From: [Miller, Ed](#)
To: ["RILEY, Jim"](#)
Subject: Comments on Dam Failure White Paper
Date: Friday, August 17, 2012 8:56:00 AM
Attachments: [Dam Failure August 8 2012.docx](#)

POST-FUKUSHIMA NEAR-TERM TASK FORCE RECOMMENDATION 2.1
Supplemental Guidance for the Evaluation of Dam Failures

Post-Fukushima Near-Term Task Force Recommendation 2.1
Supplemental Guidance for the Evaluation of Dam Failures
August 2, 2012, Revision A

Figure 1 - Dam Failure Process/Decision Flow Chart

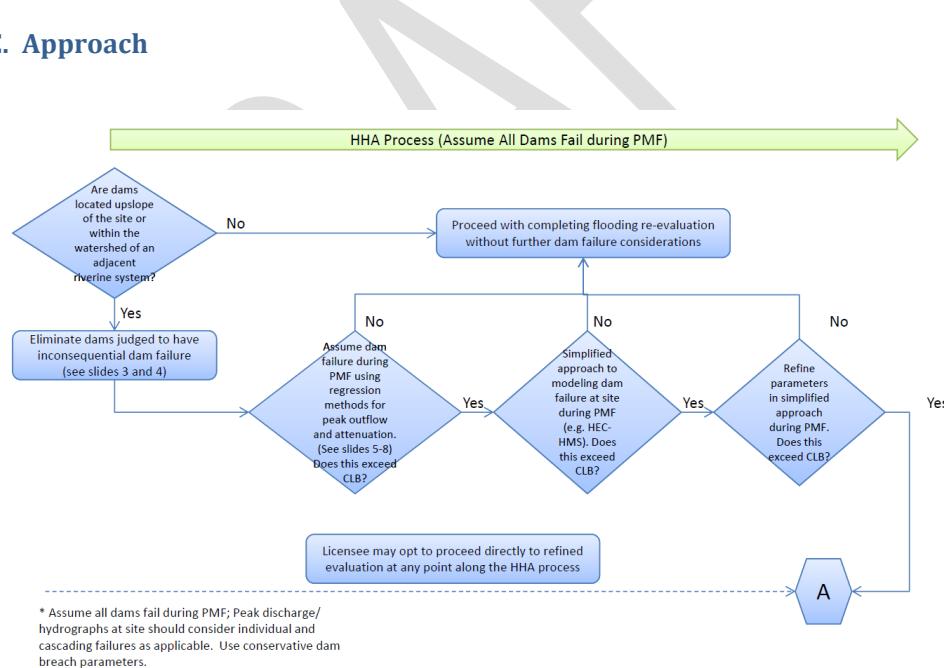
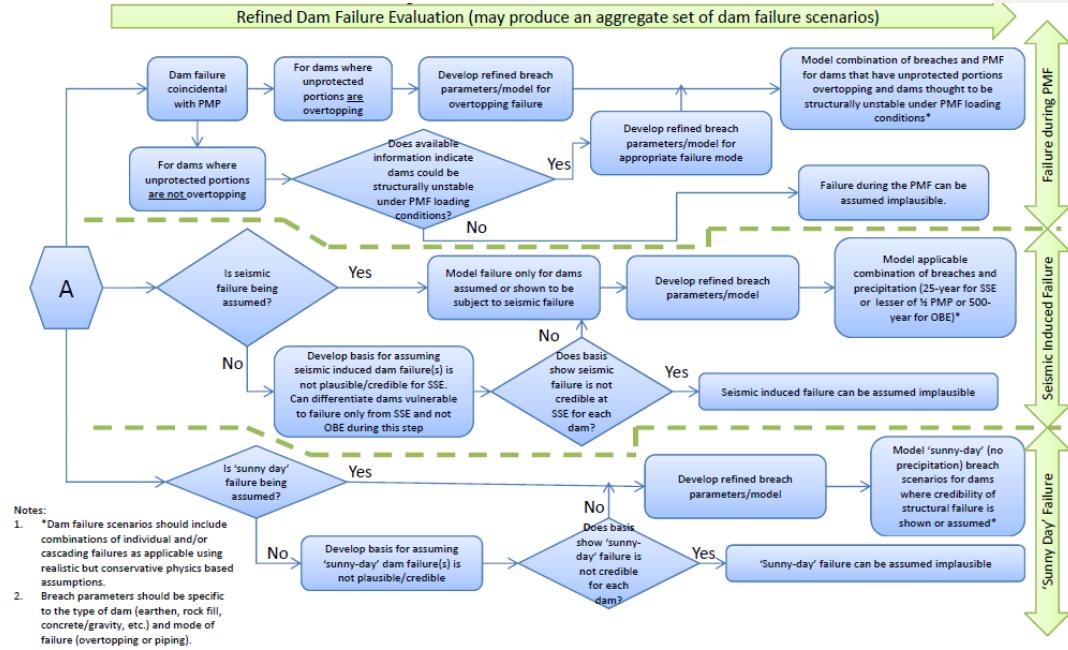
Comment [g9]: Dams that are not screened out are assumed to fail

[Recommend update flowchart based on subsequent discussions](#)

Figure 2 – Distance/Height of Dam Plot

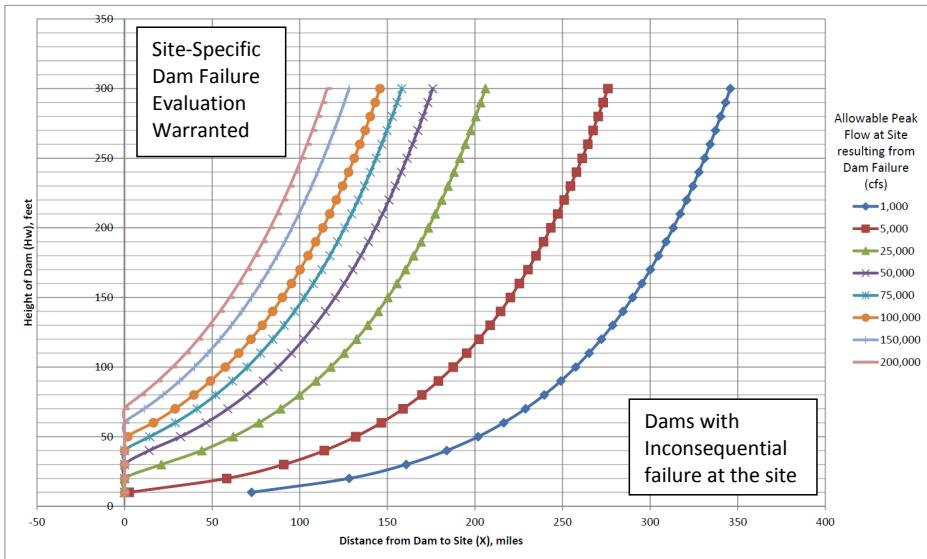
Comment [g10]: Possibly move to an appendix.

Describe limits of scope of applicability (downstream distance, dam height, etc...) and reflect limits in figure.

Comment [g13]: Needs further development to address this issue
